Project: IEEE P802.15 Study Group for Wireless Personal Area Networks (WPANs)

- Submission Title:** PSSS proposal – Parallel reuse of 2.4 GHz PHY for the sub-1-GHz bands
- Date Submitted:** 7th April 2005
- Source:** Andreas Wolf, DWA Wireless GmbH and Hans van Leeuwen, STS-wireless
DWA Wireless GmbH
Tel.: +49 (0)700 965 32 637 aw@dw-a.com
STS BV, The Netherlands
Tel: +31 20 4204200, cell +1 858 344 5120 hvl@sts.nl

- Re:** PSSS mode for more even chiprates, simpler filter, and 250 kbit/s in 868 MHz
- Abstract:** Ballot comments received indicated interest in the TG4b task group to modify the PSSS mode for 868 MHz to have the same 250 kbit/s bitrate as the 2.4 GHz and the PSSS 915 Mhz modes.

No modification of the basic PSSS model: PSSS 250-400 868 MHz – BPSK/ASK (20/32 bit/s/Hz)

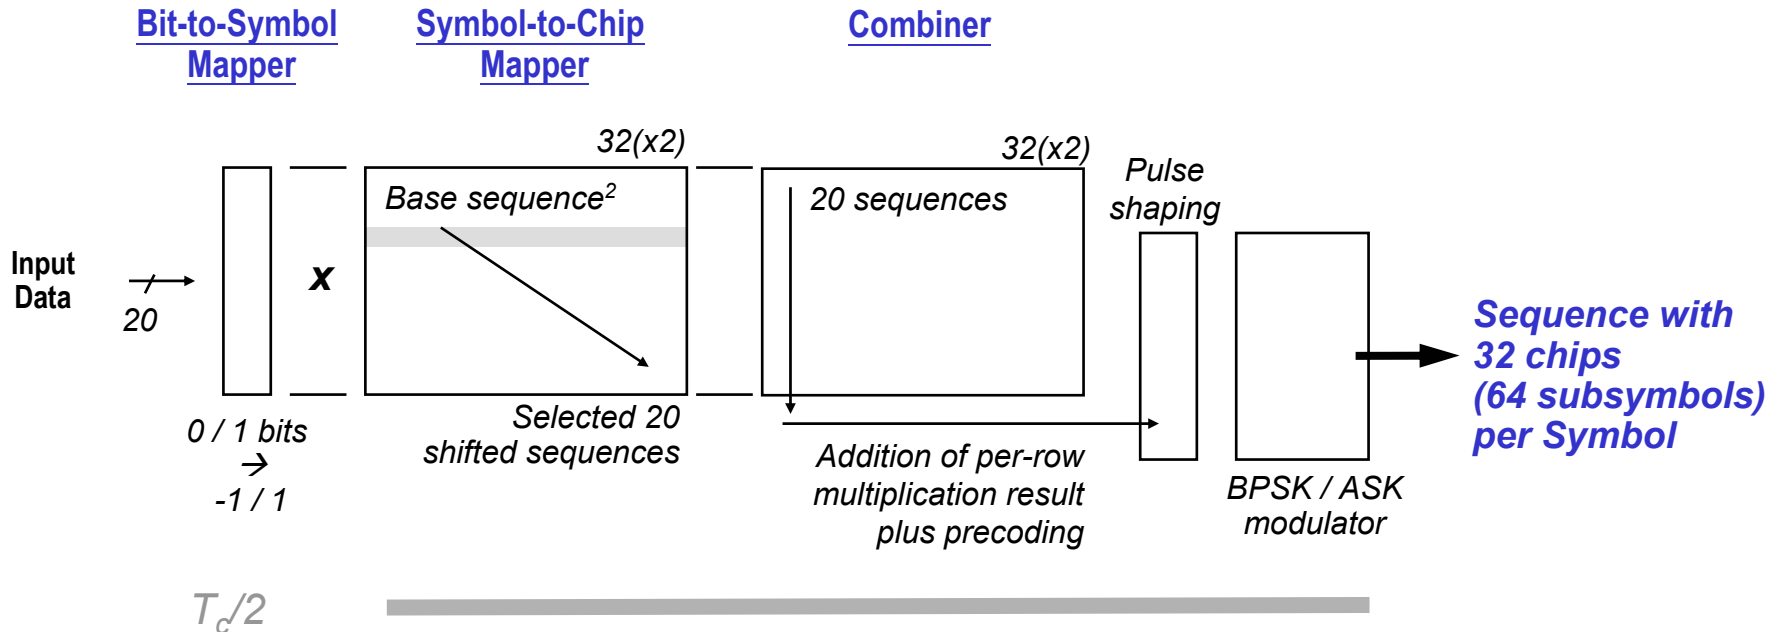
- **No increase of Tx complexity in real-world implementation –**
 - Oversampling used for baseband filtering to achieve PSD compliance anyhow
 - No change in number of chips per symbol – no increase in coding table sizes
- **Simpler baseband filter sufficient due to lower chiprate**
- **No change in Rx processing required**

PER Performance PSSS 250-400 868 MHz (BPSK/ASK) – Discrete Exponential Channel, 250ns RMS Delay Spread

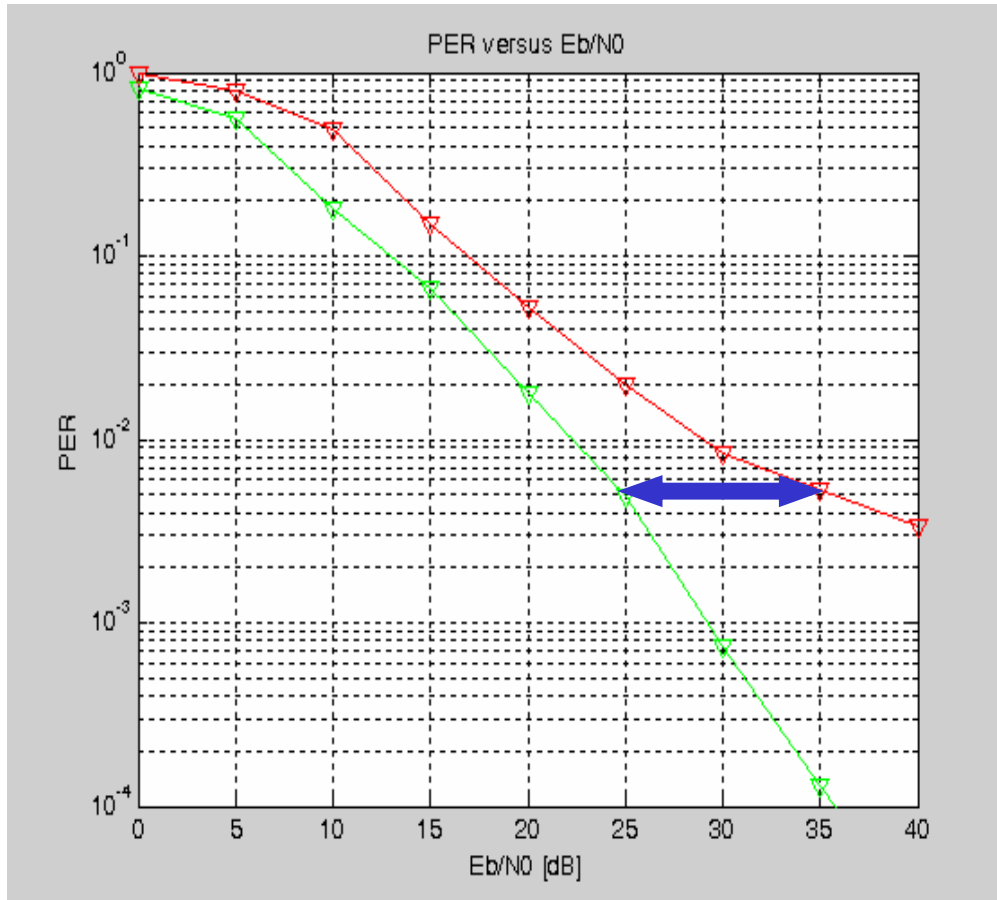
Comparison to PSSS 206-440 868 MHz

- No visible degradation of performance

PER Performance PSSS 250-400 868 MHz (BPSK/ASK) – Discrete Exponential Channel, 370ns RMS Delay Spread

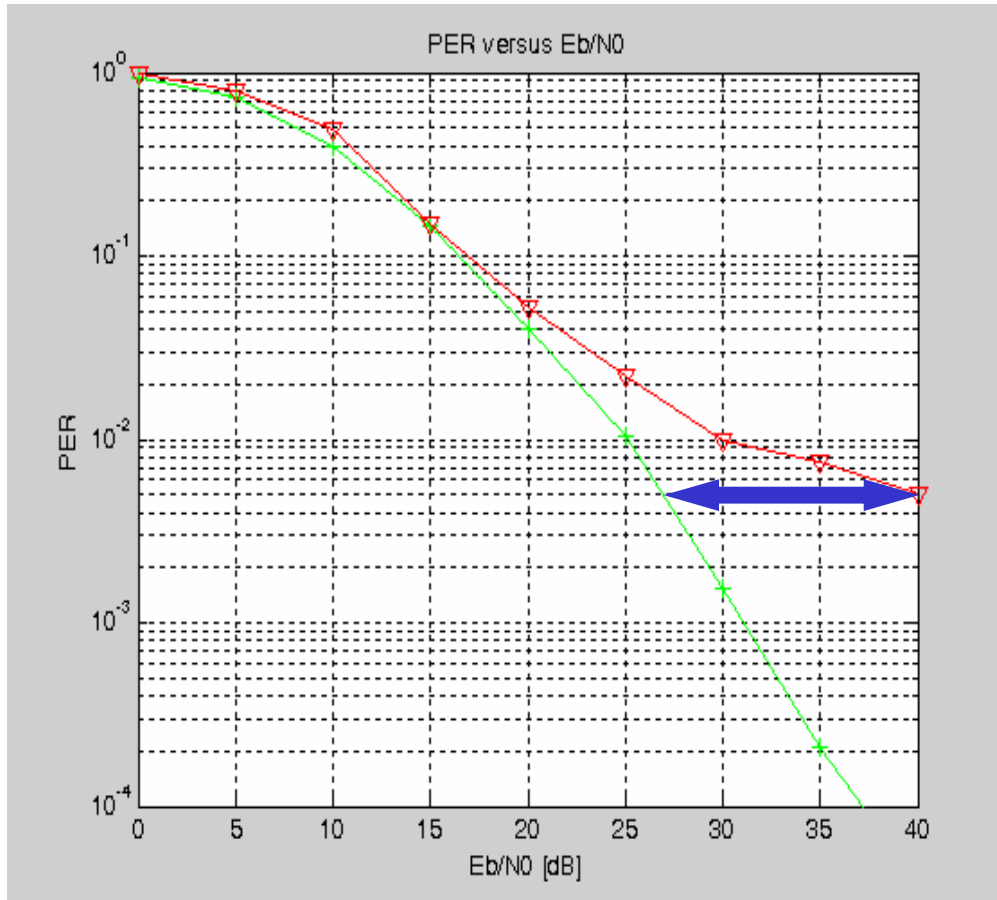
Comparison to PSSS 206-440 868 MHz

- No visible degradation of performance
